Technical Service Bulletin: TSB130063

Released Date: 13-Dec-2013

QST30 New Oil Suction Tube and Brackets

Figure 1: Obsolete Center-Mount Bracket (1) and Clamps (2)

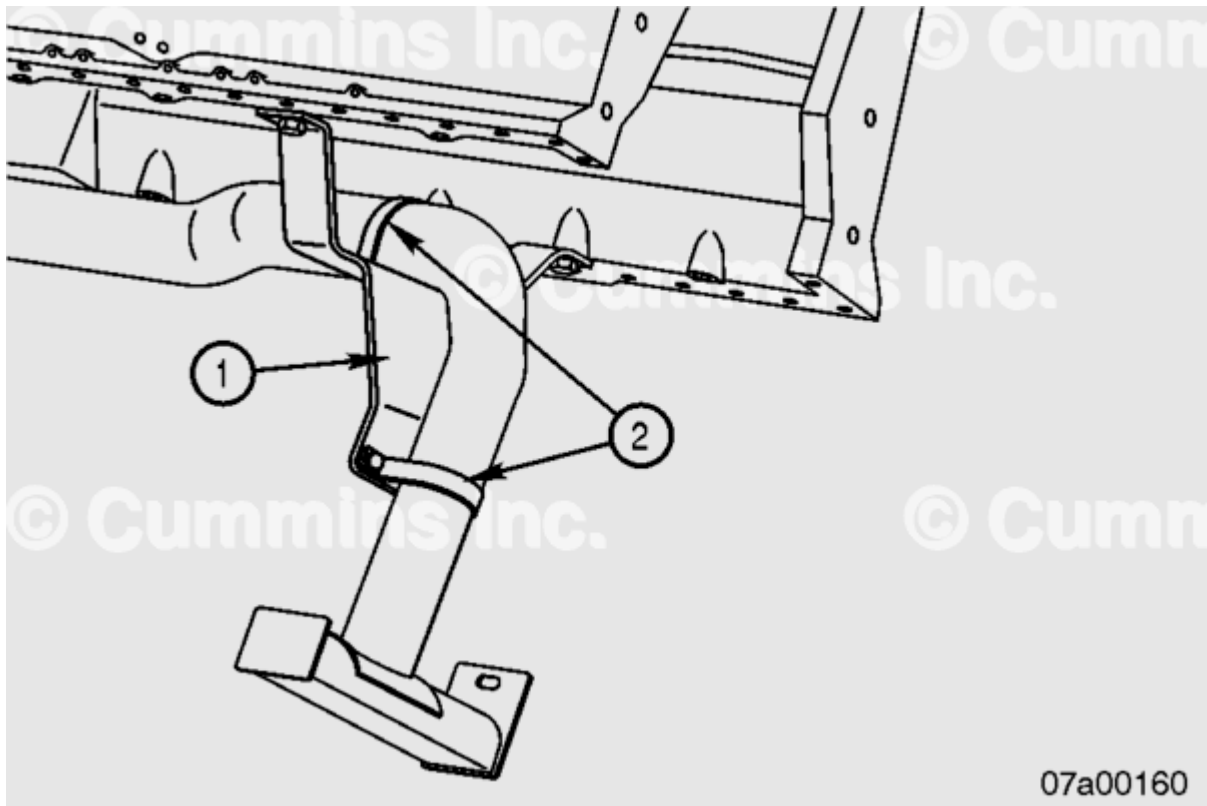
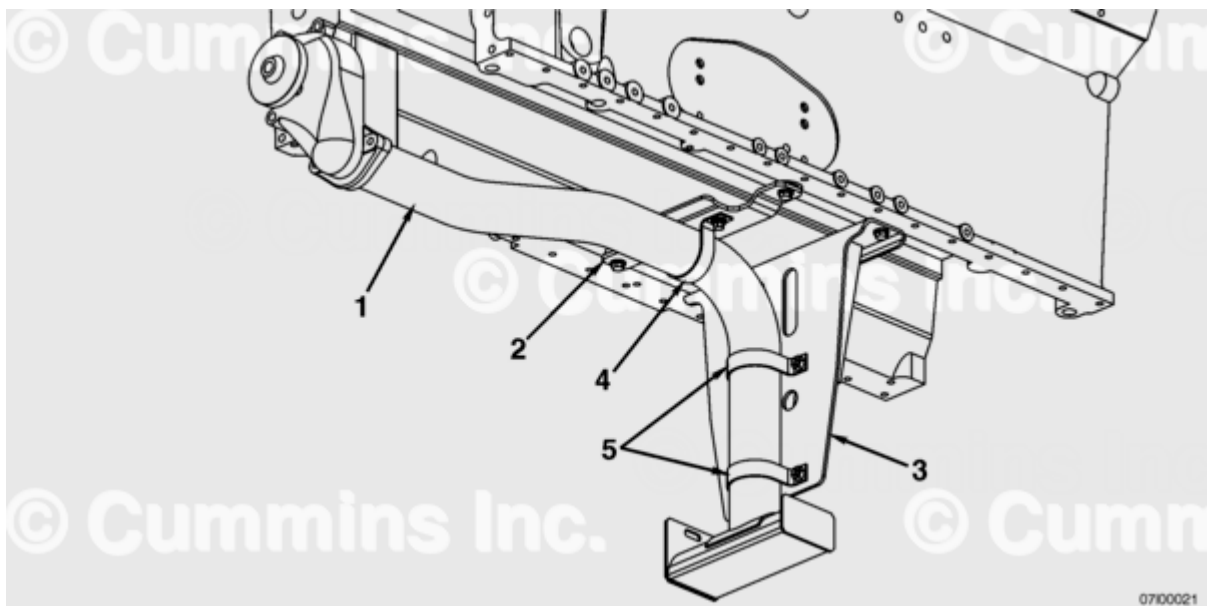
This document introduces a new lubricating oil suction tube and brackets for QST30 rear deep sump applications; Option OP5137 **only**. The oil suction tube and brackets have been designed to reduce cracking of the oil suction tube, caused by vibration.

The new tube is made of a thicker material. In addition the pickup was moved forward over the previous design. The bracket design has changed from a single center-mount bracket, to a block-mounted bracket and a vertical bracket.

Figure 2: New Suction Tube (1), Block Bracket (2), Vertical Bracket (3), Block Bracket Tube Clamp (4), and Tube Clamp (5)
